SUBJECT: SOUTH TEXAS PROJECT, UNITS 1 AND 2 - ISSUANCE OF AMENDMENTS
RE: REVISION TO TECHNICAL SPECIFICATION 5.1, "SITE" (TAC
NOS. MF1506 AND MF1507)

AMENDMENT TO FACILITY OPERATING LICENSE

SAFETY EVALUATION BY THE OFFICE OF NUCLEAR REACTOR REGULATION

SOUTH TEXAS PROJECT, UNITS 1 AND 2

FIGURE 5.1-1
EXCLUSION AREA

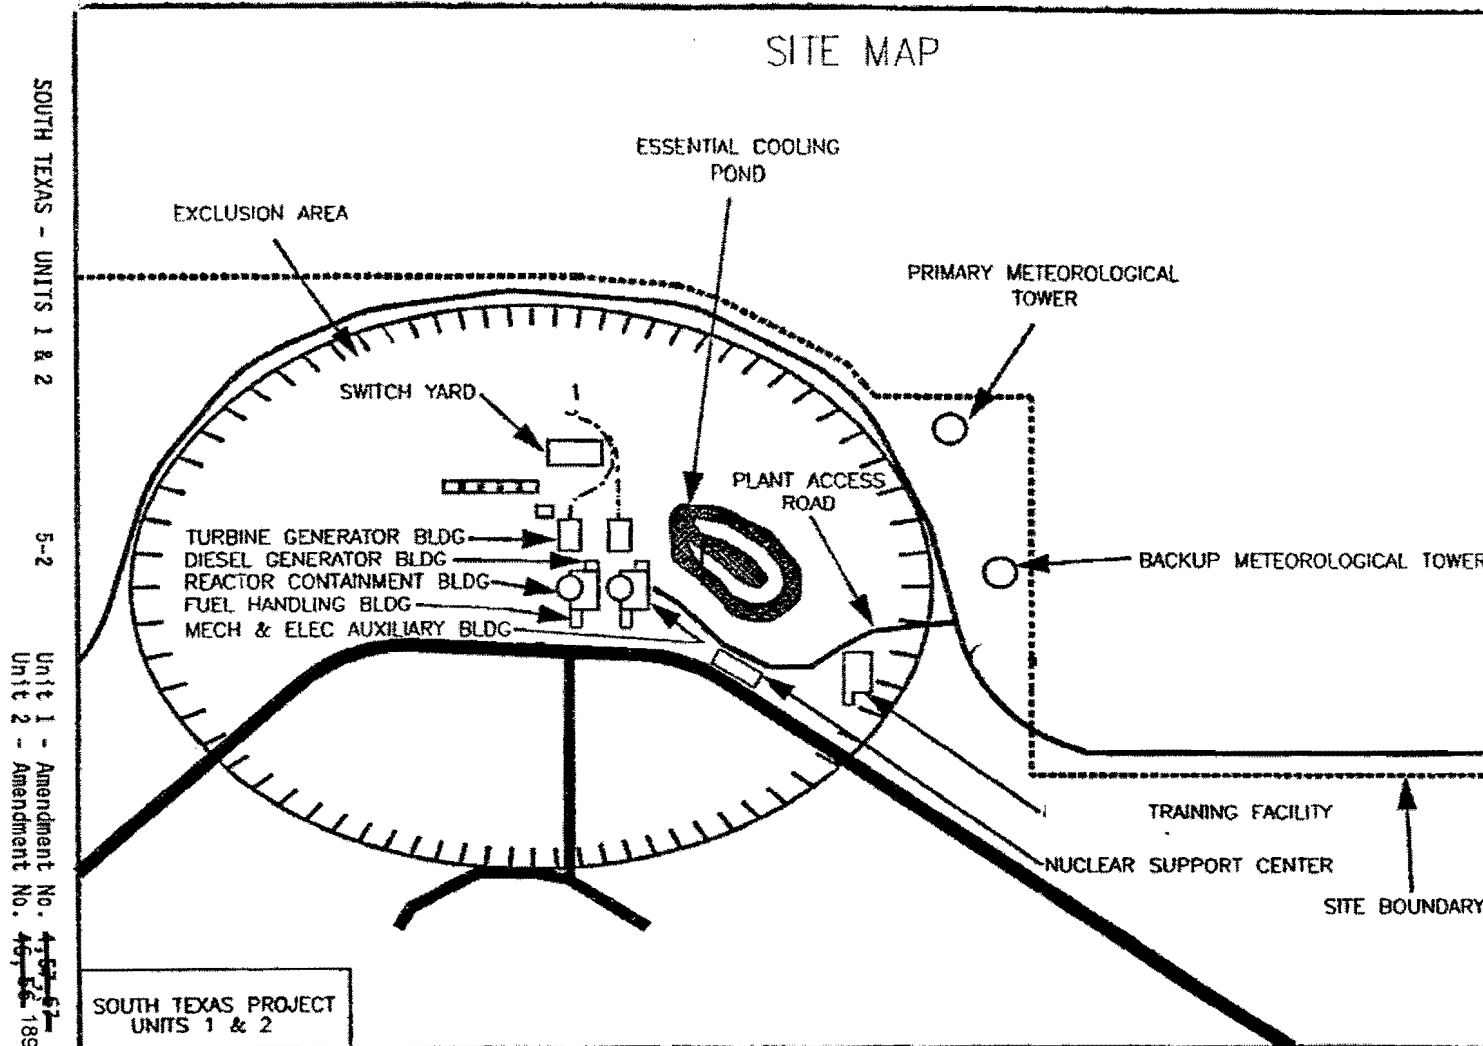
3.2.1 Figure 5.1-1 – Exclusion Area

Figure 5.1-1 is a map of the plant site showing the Exclusion Area and location of the meteorological towers. The figure also shows the location of the Visitor's Center and EOF. However, the Visitor's Center has already been demolished and the EOF was relocated to the Center of Energy Development building in Bay City, Texas. The EOF was relocated offsite with an emergency plan change made by the licensee under 10 CFR 50.54(q) in 2009 and, as stated by the licensee in its letter dated April 25, 2013, it did not represent a decrease in effectiveness and did not require NRC staff approval (Reference: STPNOC letter dated December 10, 2009, ADAMS Accession No. ML093510267). The proposed change removes references to the Visitor's Center and EOF from Figure 5.1-1. The proposed change does not impact the existing Exclusion Area. It also does not impact the location of the meteorological towers. Since the proposed change is to reflect the as-built condition of the plant and is administrative in nature, the NRC staff concludes the change is acceptable.

FIGURE 5.1-2
LOW POPULATION AREA

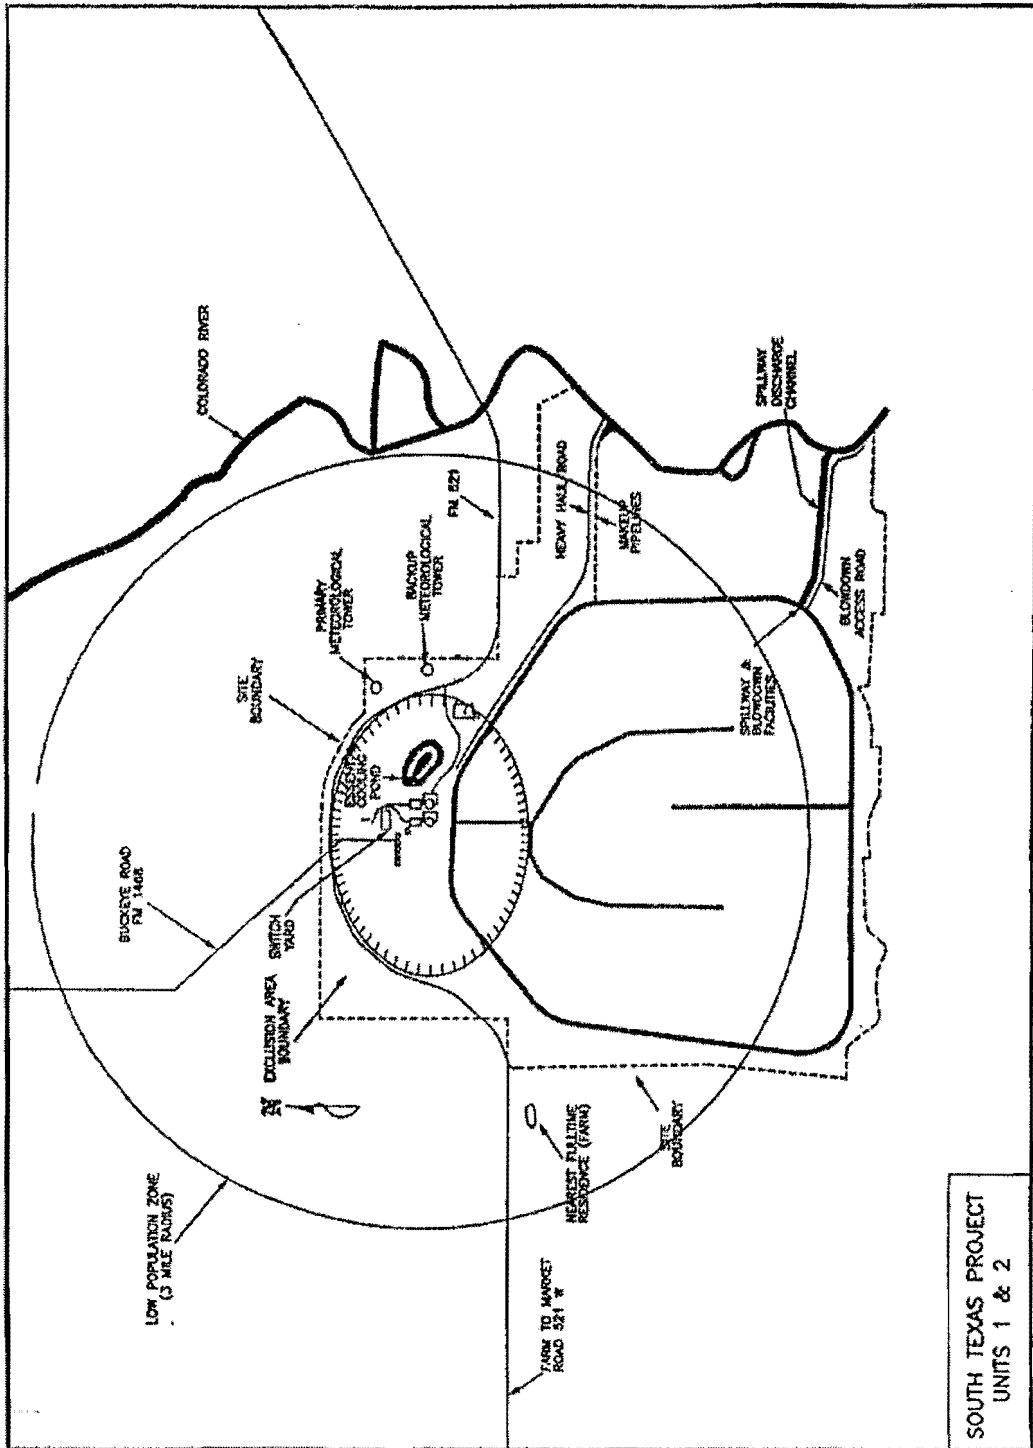
3.2.2 Figure 5.1-2 – Low Population Area

Figure 5.1-2 is a map of the plant site showing Low Population Zone (LPZ). The figure also shows the location of the Visitor's Center. However, the Visitor's Center has already been

demolished. The proposed change removes reference to the Visitor's Center from Figure 5.1-2. The NRC staff concludes the proposed change does not impact the existing LPZ and is acceptable since it reflects the as-built condition of the plant and is administrative in nature.

FIGURE 5.1-3
UNRESTRICTED AREA AND SITE BOUNDARY FOR RADIOACTIVE GASEOUS EFFLUENTS
(SEE ALSO FIGURE 5.1-4)

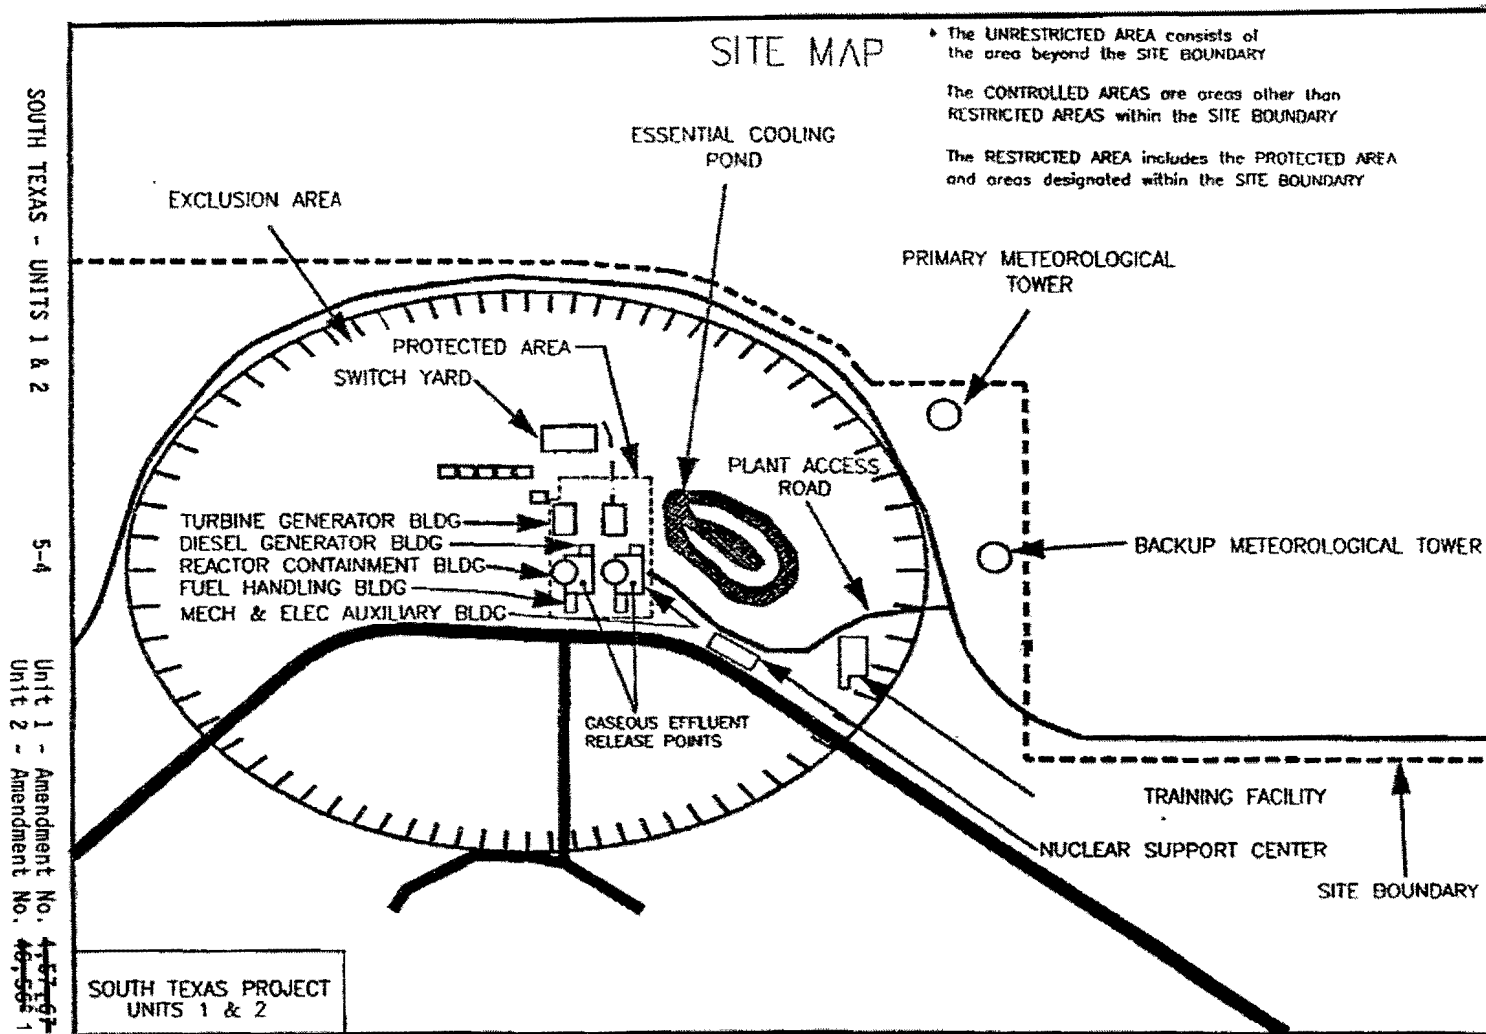
3.2.3 Figure 5.1-3 – Unrestricted Area and Site Boundary for Radioactive Gaseous Effluents and Figure 5.1-4 – Unrestricted Area and Site Boundary for Radioactive Liquid Effluents

Figures 5.1-3 and 5.1-4 provide information regarding radioactive gaseous and liquid effluents, which allow identification of structures and release points as well as definition of UNRESTRICTED AREAS within the SITE BOUNDARY that are accessible to the members of the public. The figures also show the location of the Visitor's Center and EOF. However, as stated earlier, the Visitor's Center has already been demolished and the EOF was relocated to Center of Energy Development building in Bay City, Texas, in 2009. The proposed change removes references to the Visitor's Center and EOF from Figures 5.1-3 and 5.1-4. There is no change to the site boundary for radioactive gaseous and liquid effluents. Also, the change does not affect the methodology or parameters used in the Offsite Dose Calculation Manual for the calculation of the radioactive gaseous and liquid effluents. Since the proposed change is to reflect the as-built condition of the plant and is administrative in nature, the NRC staff concludes the change is acceptable.
